4009 Hub Cap Side Fill Design Change

TO: ALL DISTRIBUTORS OF STEMCO WHEEL END PRODUCTS

Old Design

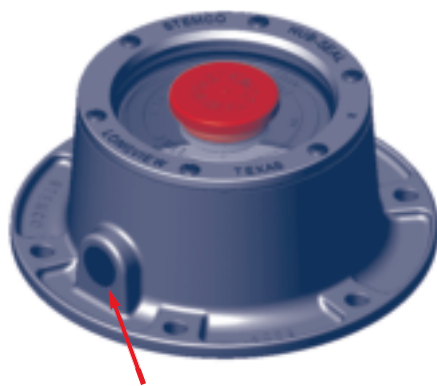
STEMCO introduces a new 4009 hub cap side fill casting design change as a continuous improvement effort to aid in filling oil wheel ends through the side fill plug.

A running change to the new design is targeted for release by the end of August 2007. The design change involves moving of the side fill boss further out from the flange to eliminate the chance of spindle interference when adding oil through the side fill boss.

Diseño Anterior

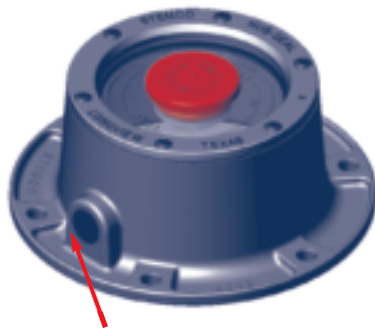
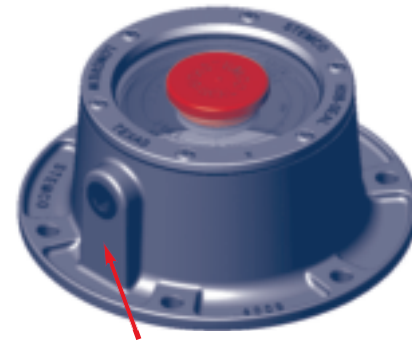
STEMCO introduce un nuevo diseño en la tapa 4009 como un esfuerzo continuo en mejorar el llenado de aceite en la Terminal de rueda por medio del orificio de la tapa.

Este cambio en el diseño esta programado para ser efectivo a finales de Agosto 2007. El cambio en el diseño consiste en extender la base junto con el orificio del llenado de aceite para evitar la posibilidad de que esta interfiera con la espiga al momento de ser llenado.
